RUD55
TRU0144

Project:	Hanse 575 RUD55 Rudder	
Scale	1:12	Date 21/05-2012
Material	Alu6082	Drawing no. TRU0144
Filename (dwg)	Hanse 575 Buildcard	
Drawn by	KJ

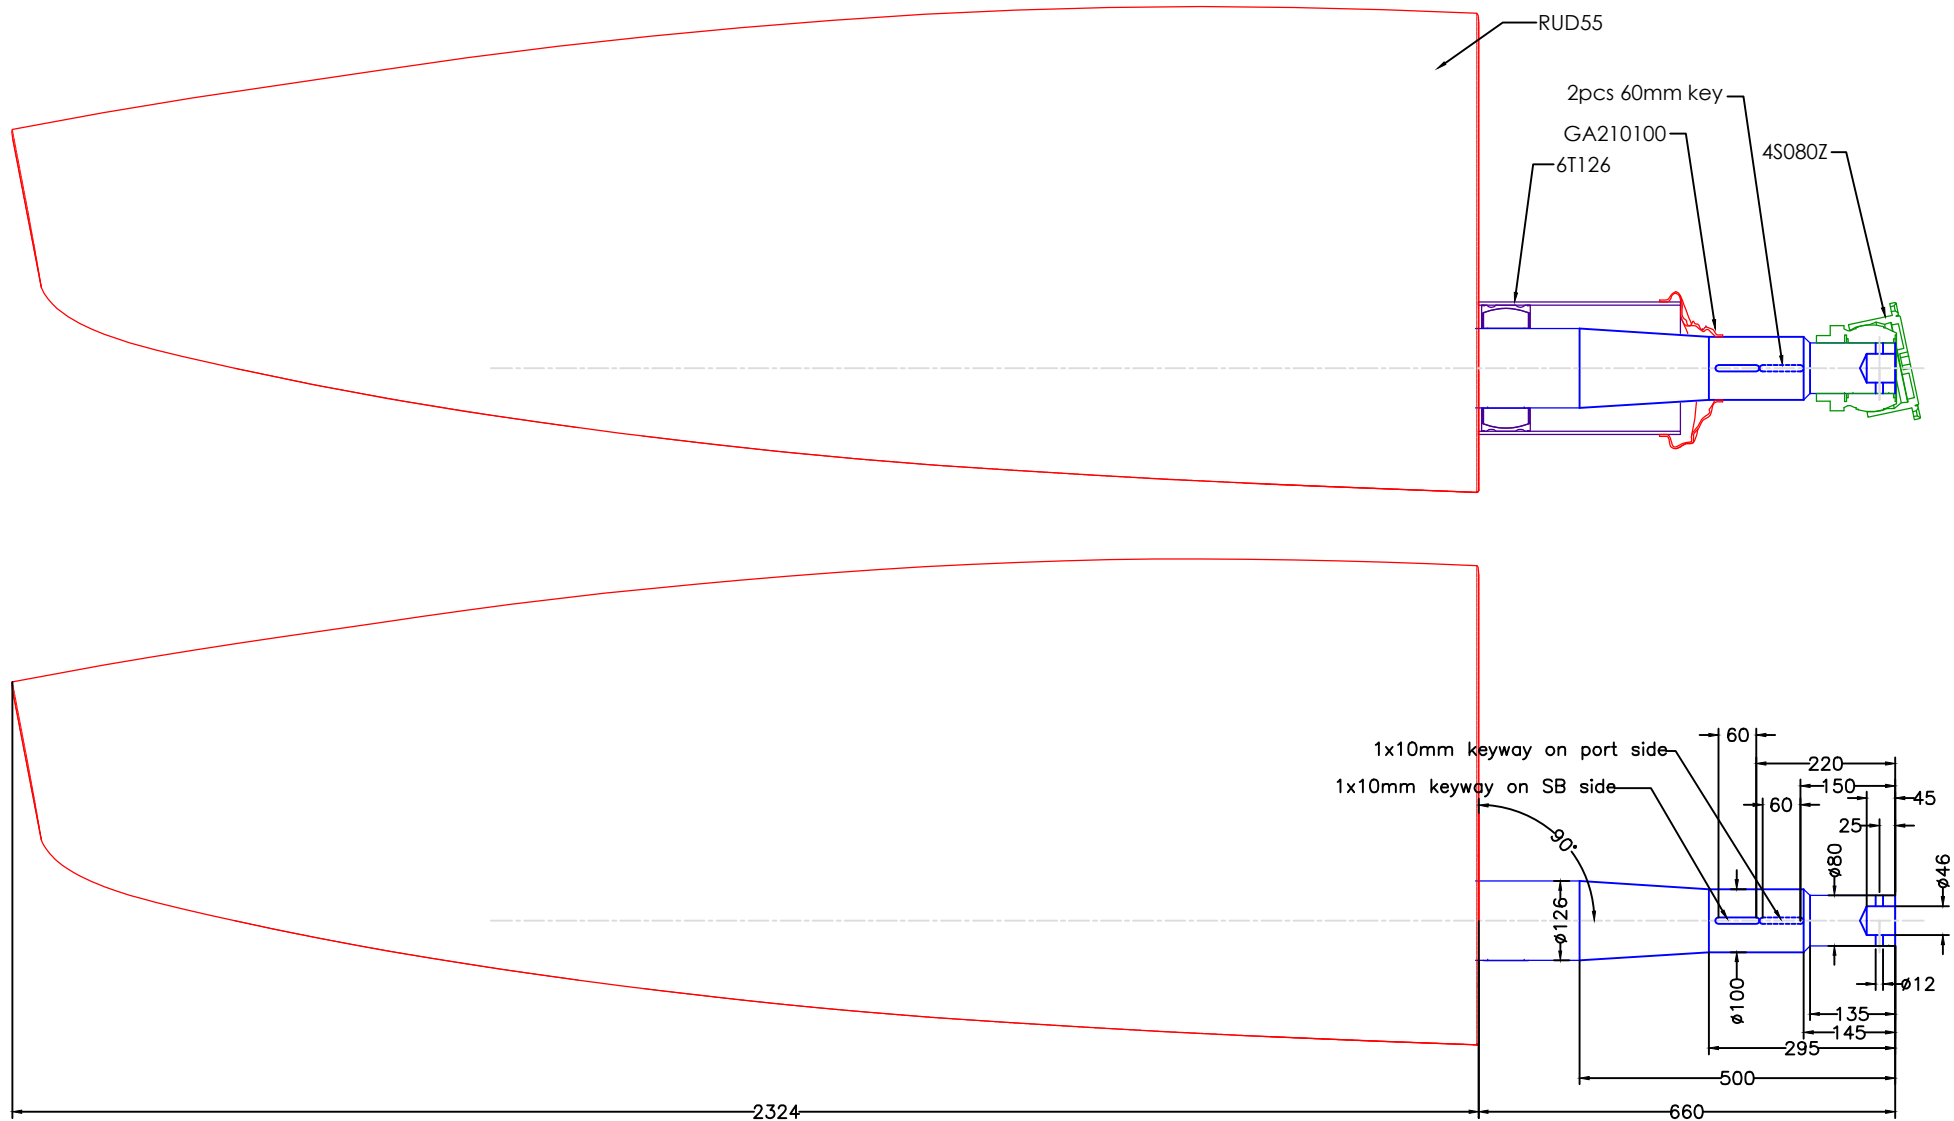
Modify date: 2012-11-29 Keyways changed from long to short (60mm)
Modify date: 2013-01-24 Rudderstock extended 30mm, from 655 to 685mm
Modify date: 2013-06-04 Rudderstock shortened 25mm, from 685 to 660mm
Modify date
Modify date
Modify date
